The Banks – Phase 3C
Public Infrastructure Development
Bid Package #2 – Lot 28 Park & Garage
January 13, 2022
THP #98090.40

ADDENDUM #2

DRAWING TITLE
STEPPED BENCH &
PLANTER @ MIDDLE
WALK

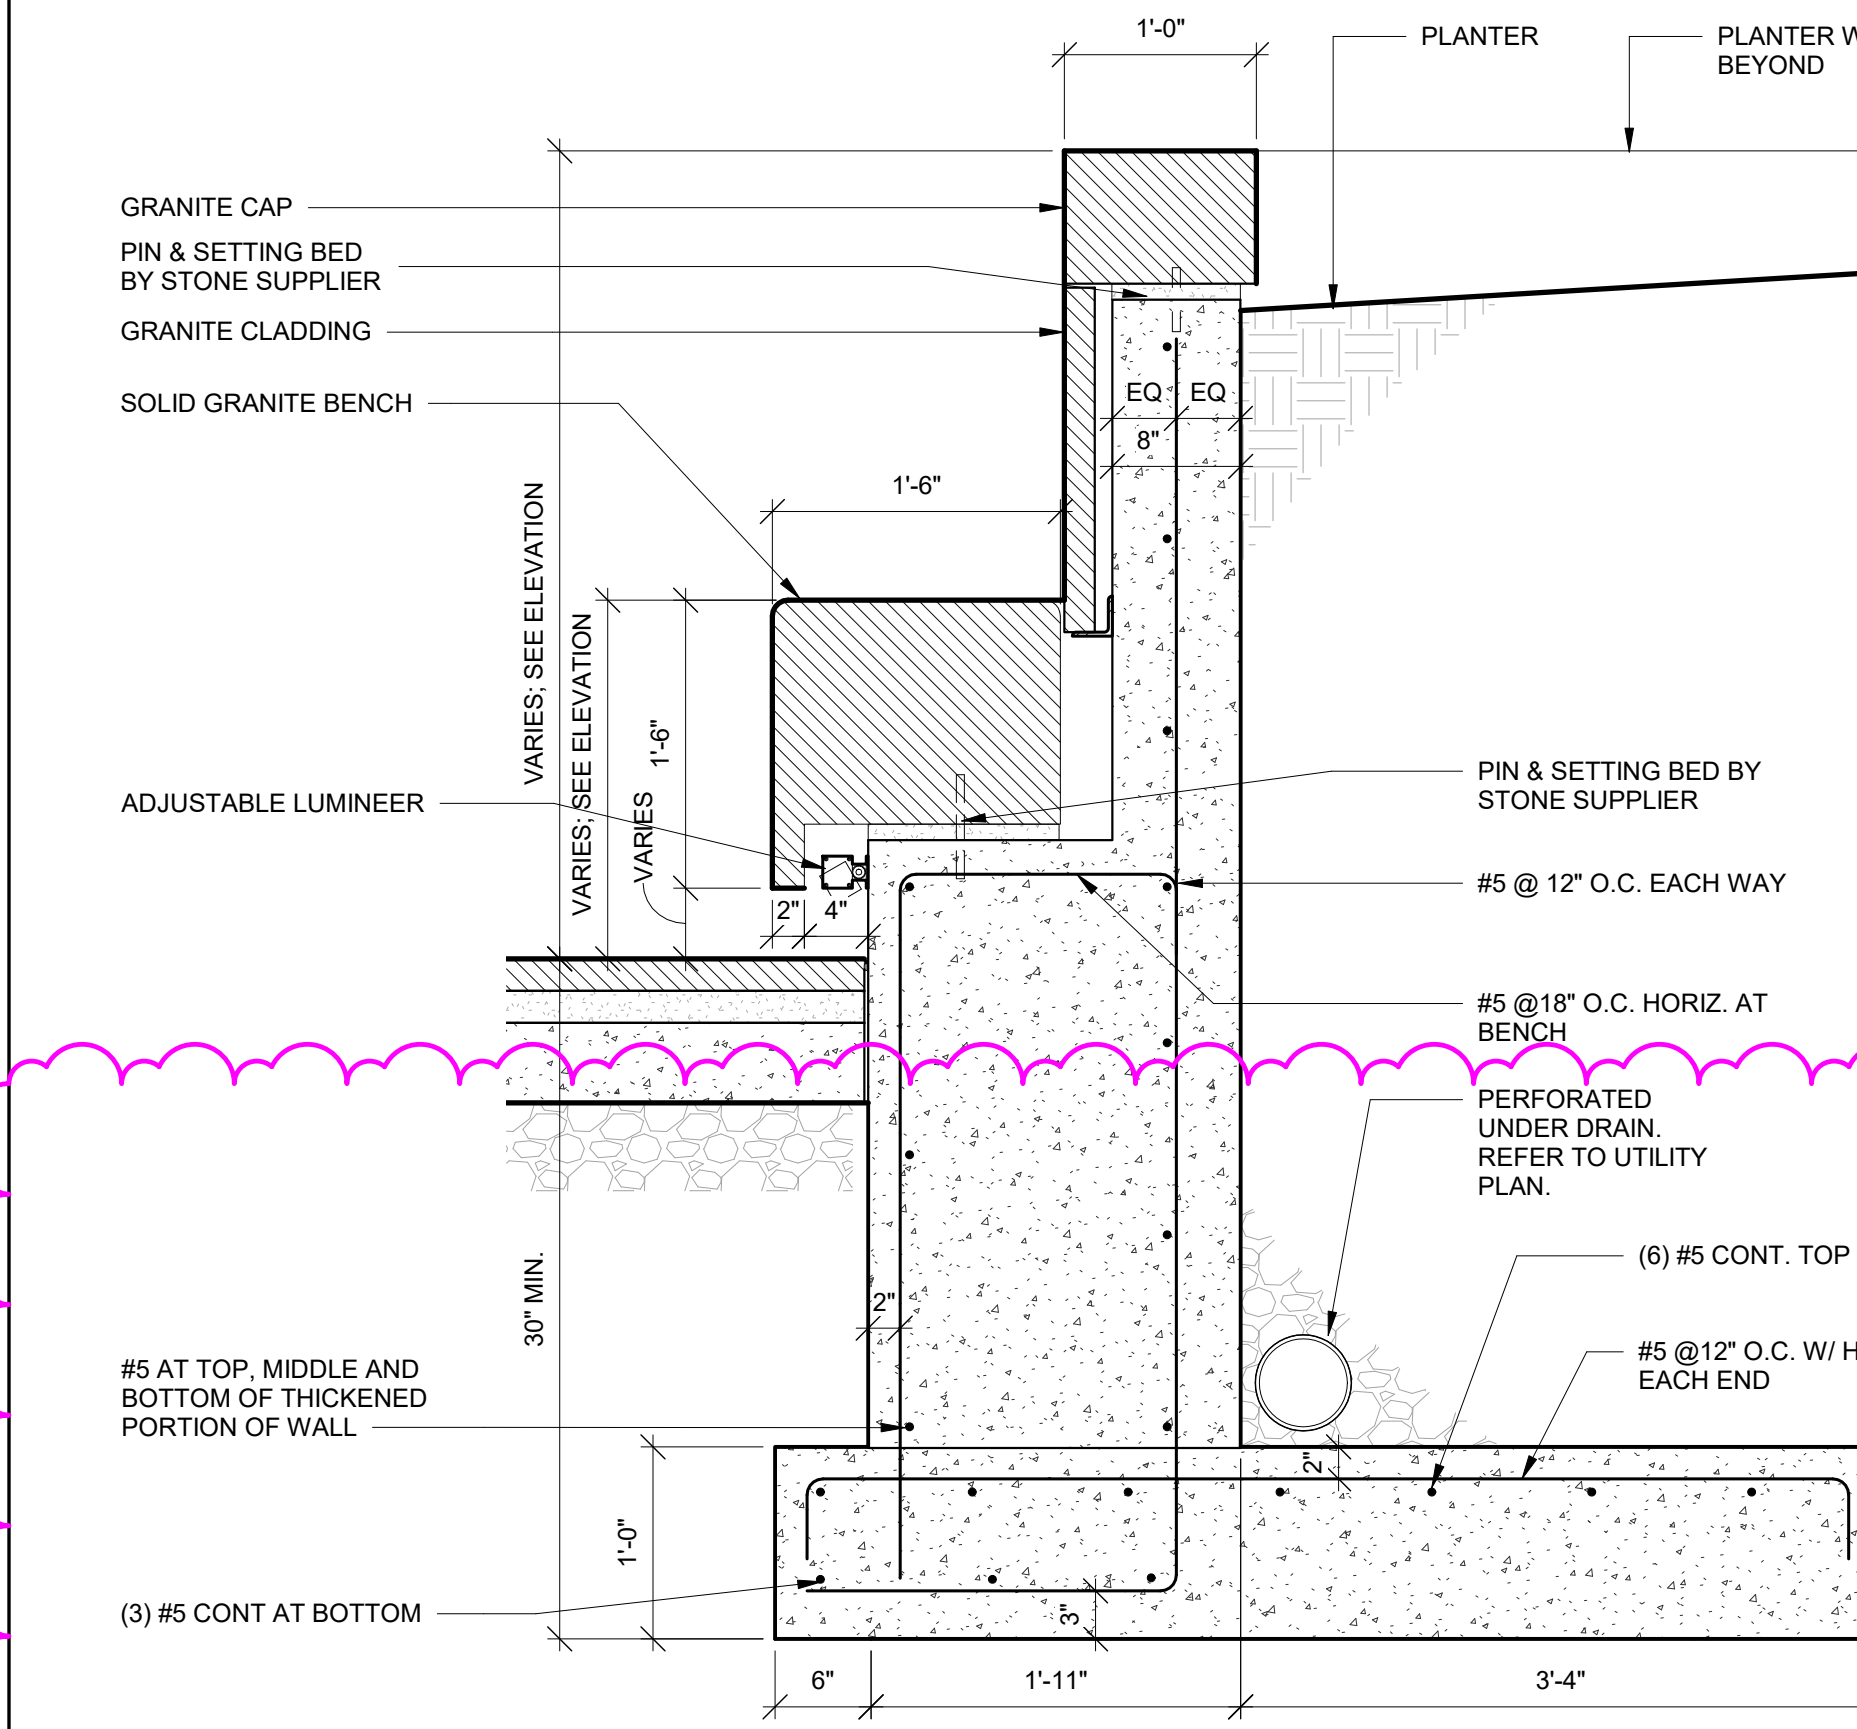
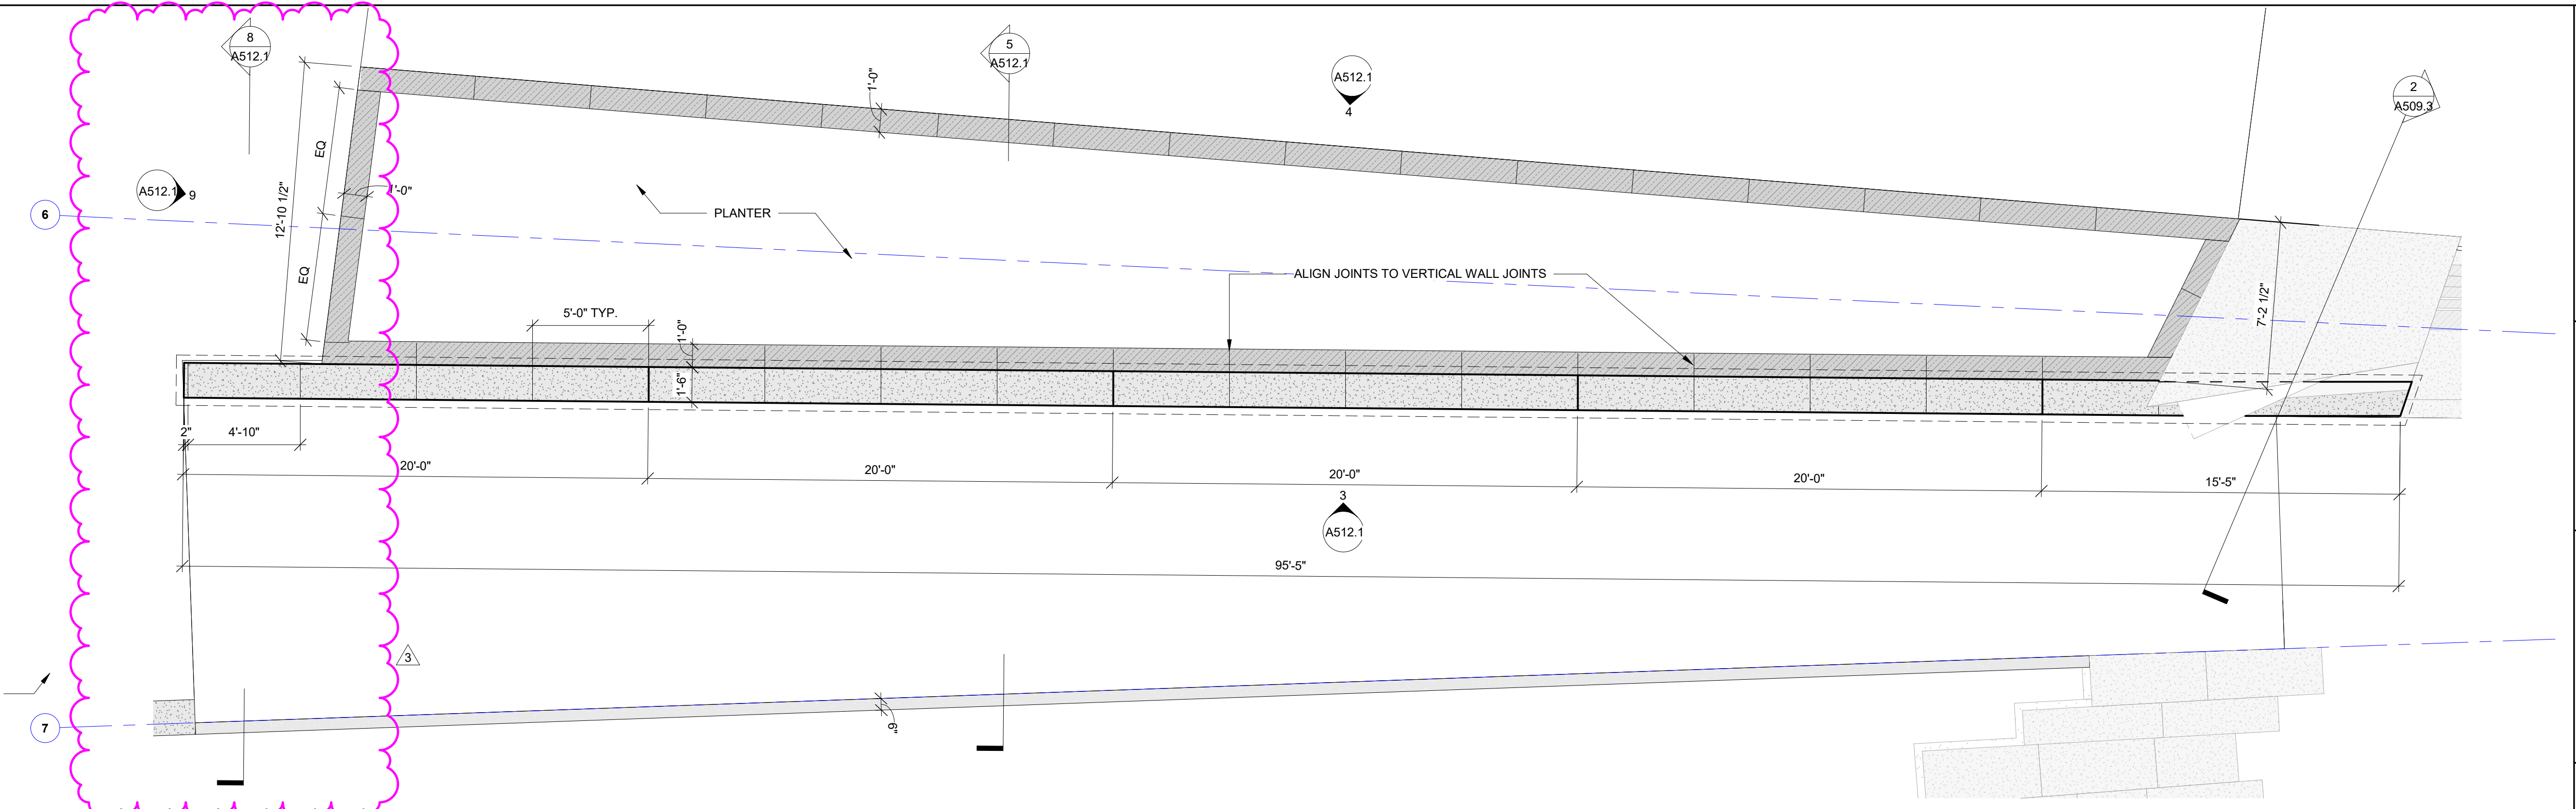
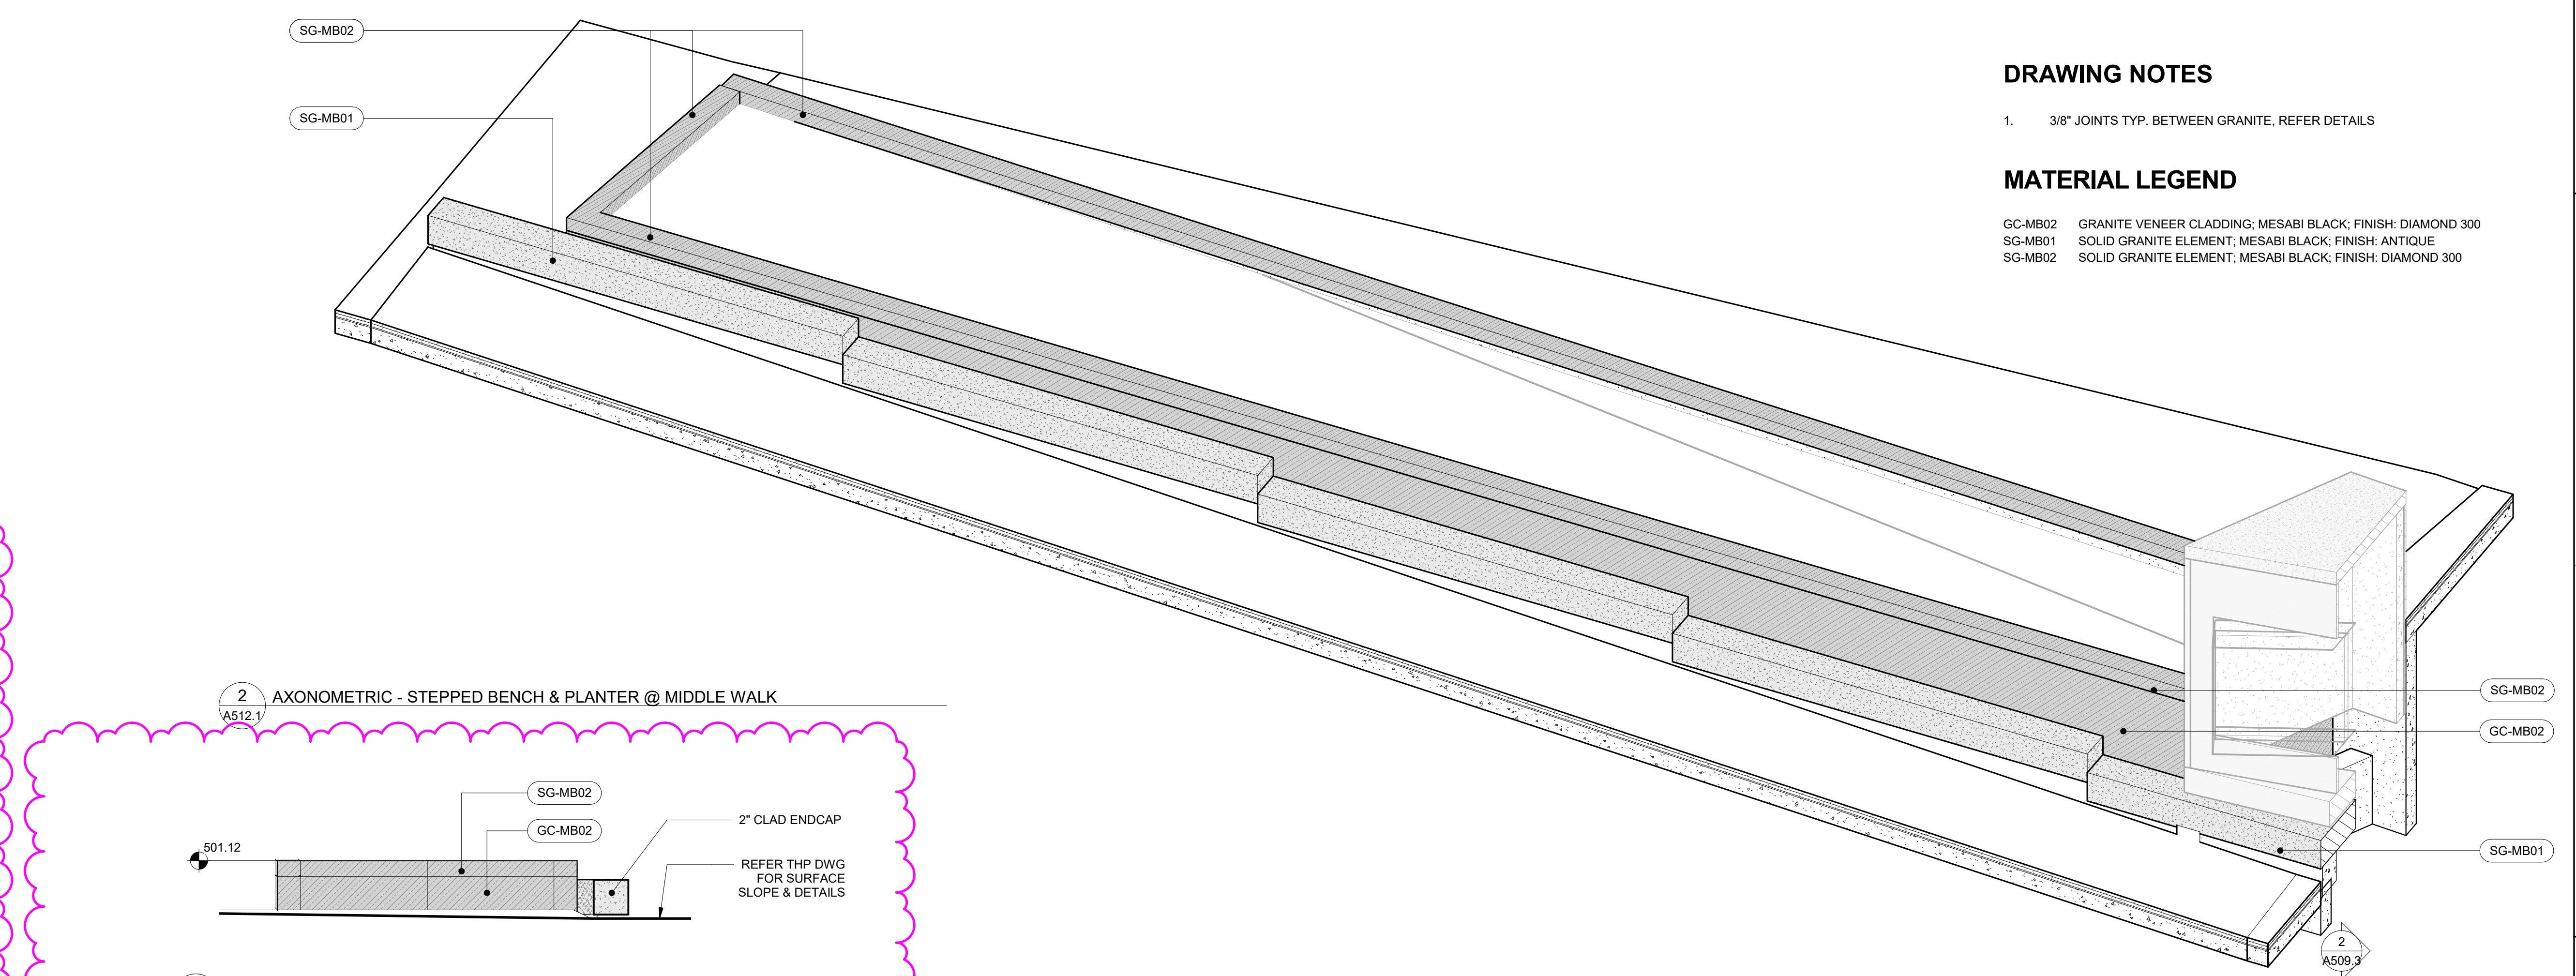
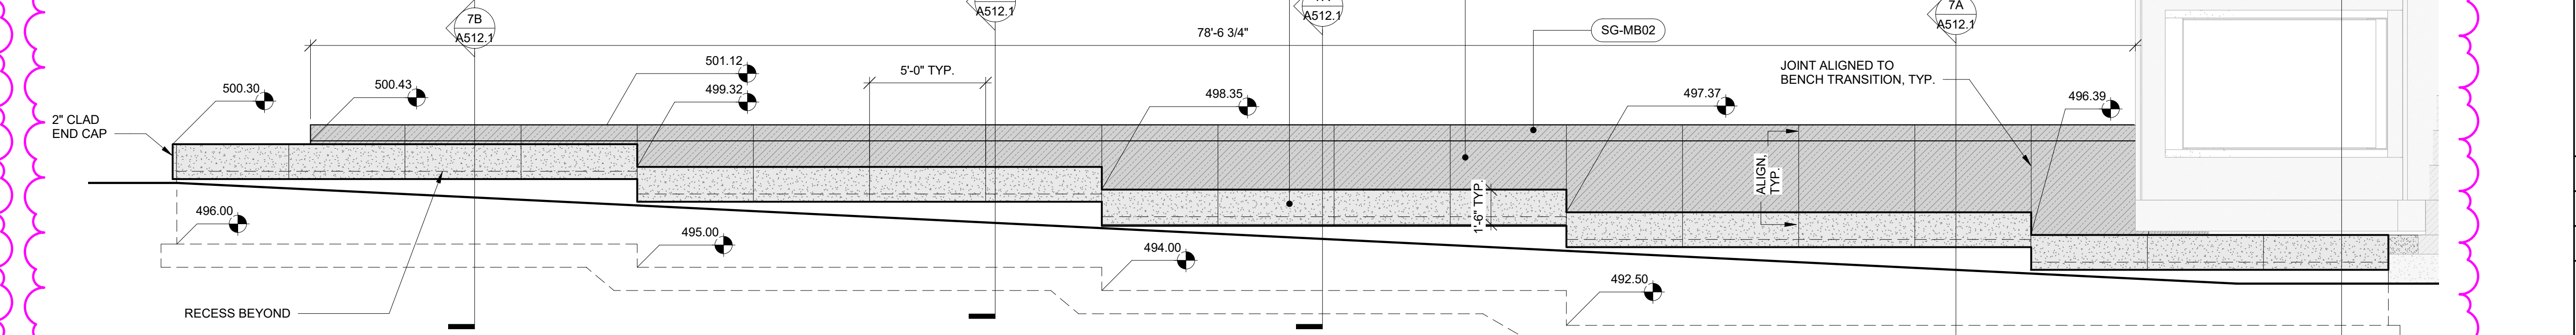
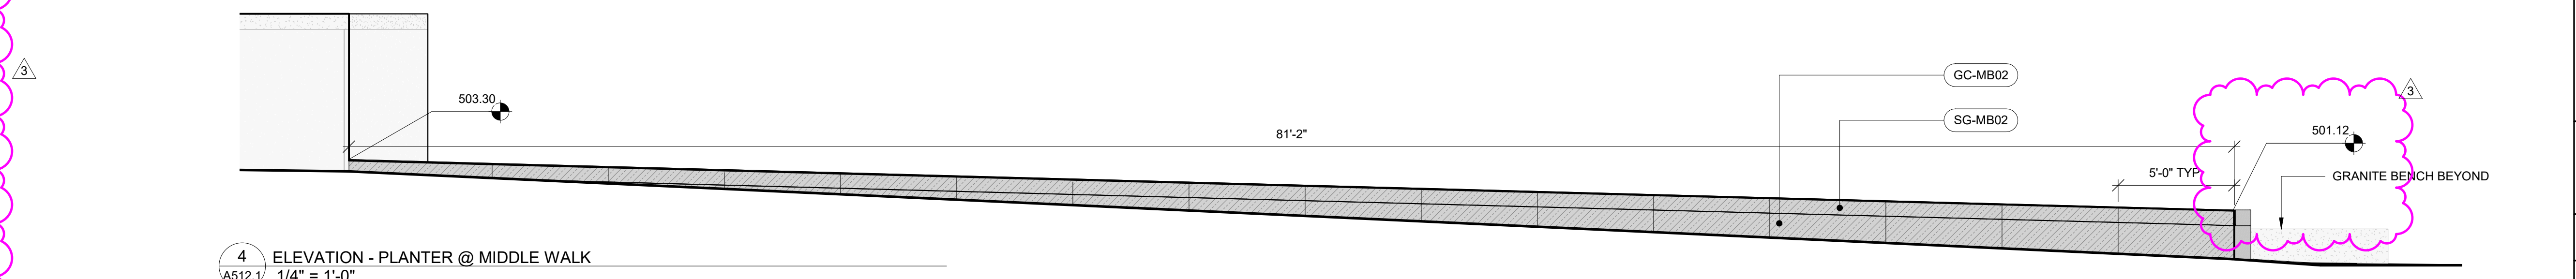
- Added section and elevation (missing info).
- Added notes to elevations.
